## **ITEM**

<b>Application Reference</b>	<b>DC/076025</b>
<b>Location:</b>	Orlando House 11 Compstall Road Marple Bridge Stockport SK6 5HH
<b>PROPOSAL:</b>	Change of use of office building to provide 7 no. residential apartments (Use Class C3a), with associated elevational alterations to the exterior of the building, including insertion of windows, doors and rooflights, application of render and cedar cladding, re-roofing, with the construction of two dormer extensions to the rear roof plane, and formation of external roof terraces with balustrading, together with the formation of associated car parking and segregated refuse and recycling provision
<b>Type Of Application:</b>	Full Application
<b>Registration Date:</b>	03/07/2020
<b>Expiry Date:</b>	28/08/2020
<b>Case Officer:</b>	Mark Burgess
<b>Applicant:</b>	Space Construction Ltd
<b>Agent:</b>	Mrs T Spencer

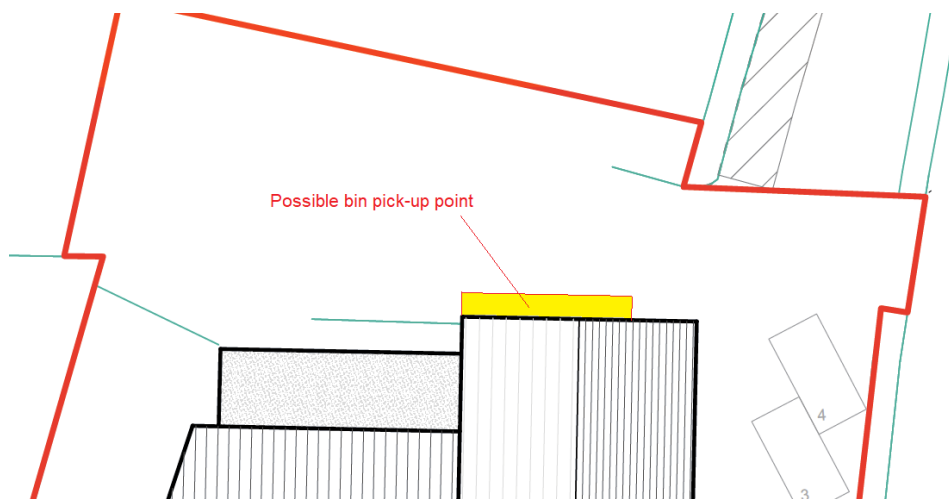
With respect to parking, I note that a disabled parking space has been provided in the rear car park in the position I recommended. As such, I consider the proposals for disabled parking acceptable.
